Buffalo River Watershed Alliance

Comments on C&H Reg 5 Permit Application

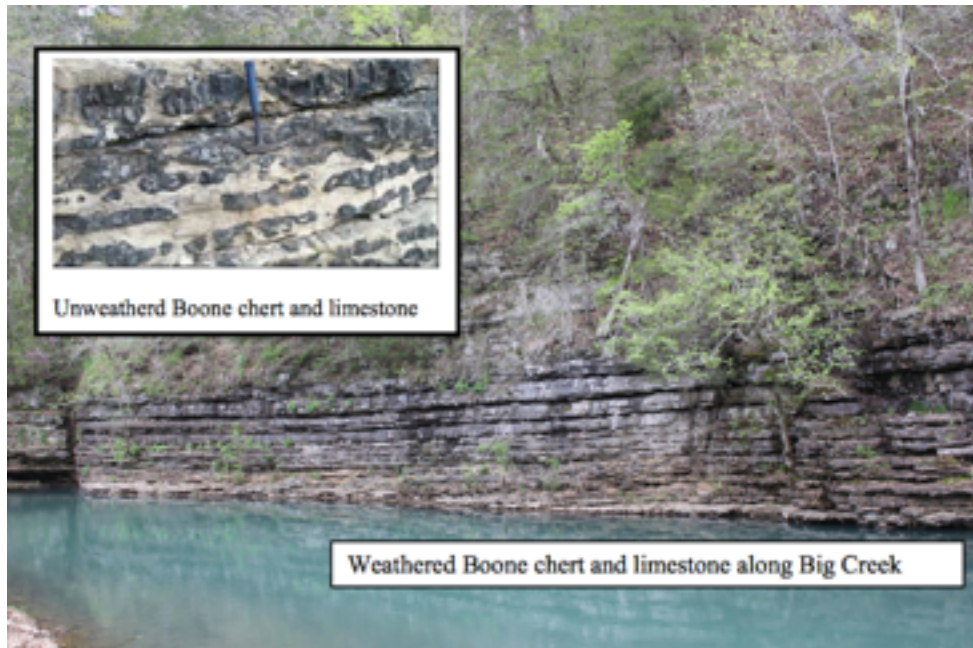
"The highly weathered limestone bedrock and unconsolidated clay intervals observed between 13.8 and 28.0 ft.bgs. appeared to have the characteristics of epikarst. With the understanding that epikarst is the weathered zone found at the interface of unconsolidated soils and bedrock, the Site setting would support this characterization."

The indication of epikarst at 13.8 to 28 ft below ground level confirms porous weathered rock at a depth that is above the floor of the ponds with the pond #2 invert at 20 ft below the surface of where the bore hole was drilled (See Appendix C12 for elevations). The AWMFH table 10-D in Appendix 10D (Appendix C-10 of this document) notes the following regarding karst in the *Vulnerability to Risk* matrix when siting a facility: “large voids e.g. karst, lava tubes, mine shafts) as a **very high** vulnerability suggesting that the engineer “**Evaluate other storage alternatives**”. No such alternatives were considered. As a result, this permit does not comply with AWMFH guidance.

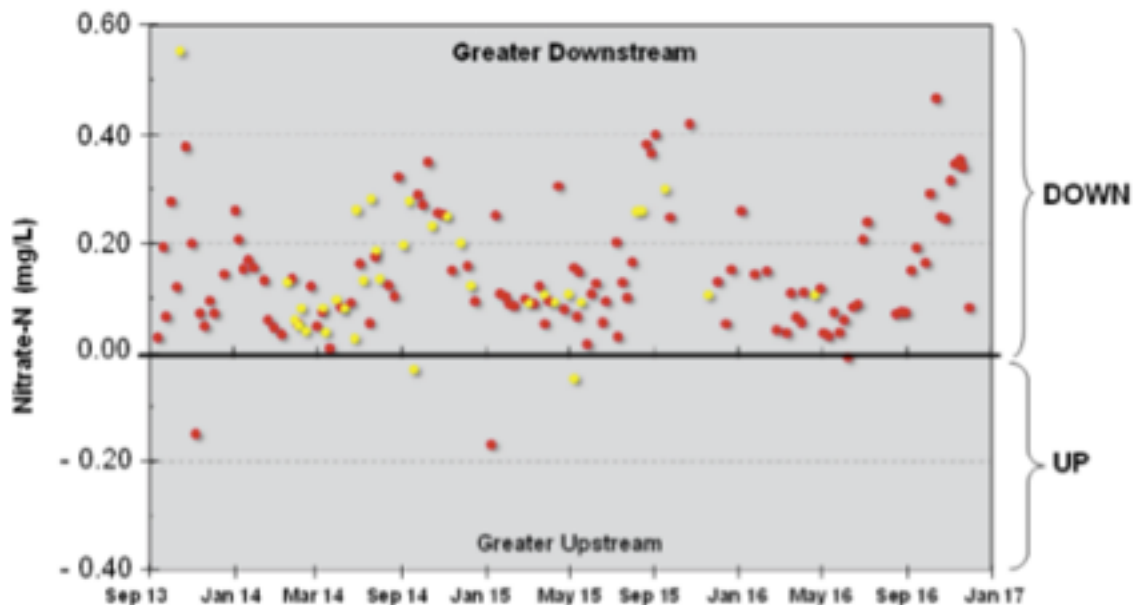
Comment D1 - This permit should be denied because Big Creek Research & Extension Team (BCRET) testing of Big Creek immediately downstream of the facility shows degradation for nitrates

Nitrates are being measured by the *Big Creek Research and Extension Team* (BCRET) of the *University of Arkansas Division of Agriculture* both upstream and downstream of the facility and nearby spreading fields Figure 1.

“Nitrate concentrations at the downstream site have been consistently higher than at the upstream site on nearly all BCRET sampling dates since swine waste applications from the C&H CAFO began (BCRET 2014a-d, 2015a-d, 2016a-d) (Figure 1). During January – November 2016, for example, paired upstream/downstream data showed that nitrate was substantially lower at the upstream station than at the downstream station on 40 of 41 sampling dates; concentrations were comparable on the remaining one date. Elevated nitrate levels near swine CAFOs are commonly used as an indicator of swine waste discharge; the wastes initially are high in ammonia, but over short distances during transport the ammonia is oxidized to nitrate (Dewi et al. 1994). Nitrate levels at the downstream site typically have been two- to three-fold higher than at the upstream site; sometimes the difference has been as high as 25-fold”

Figure 3: Dissolved Oxygen data for Big Creek (BUFT06) during August of 2015. (Source USGS)

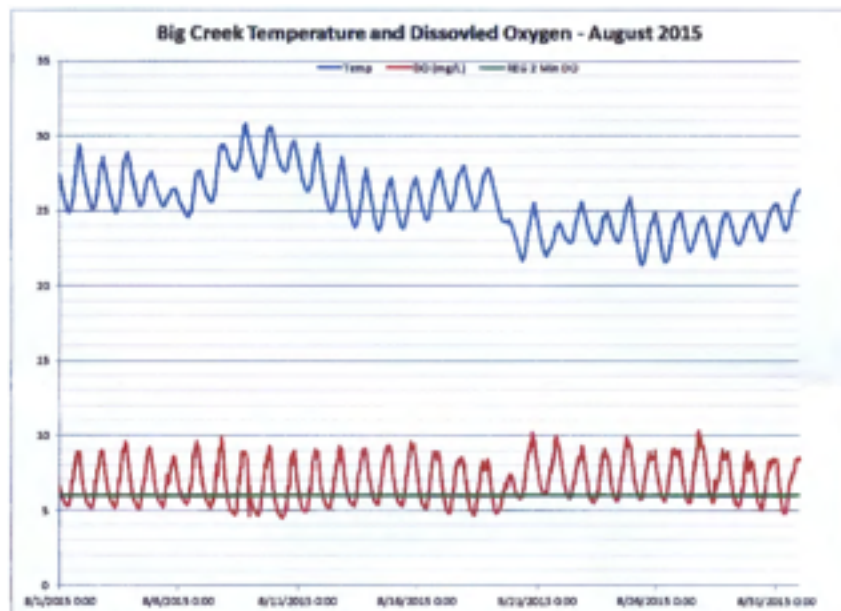
"NPS has also been monitoring the United States Geological Survey (USGS) sites collecting dissolved oxygen data on tributaries to the Buffalo River. Two of these sites have chronically been below the allowable limits in Regulation 2.505. These are Bear Creek near Silver Hill (USGS Site 07056515) (ADEQ site- BUFT12) (Figure 2) and Big Creek at Carver (USGS Site 07055814) (ADEQ site- BUFT06) (Figure 3).

These streams have had minimum dissolved oxygen values of 3.9 and 4.5 mg/L, respectively, well below the standards.”

“As dissolved oxygen is very important for aquatic life, particularly for species such as freshwater mussels, and such species are part of the suite of scenic and scientific resources Congress expected to be conserved when the Buffalo National River was established, NPS needs the assistance of ADEQ in determining the sources of low dissolved oxygen and reducing or eliminating these sources. We feel that both of these streams should be placed on the "Impaired Waterbodies" list pursuant to Section 303(d) of the Clean Water Act.”
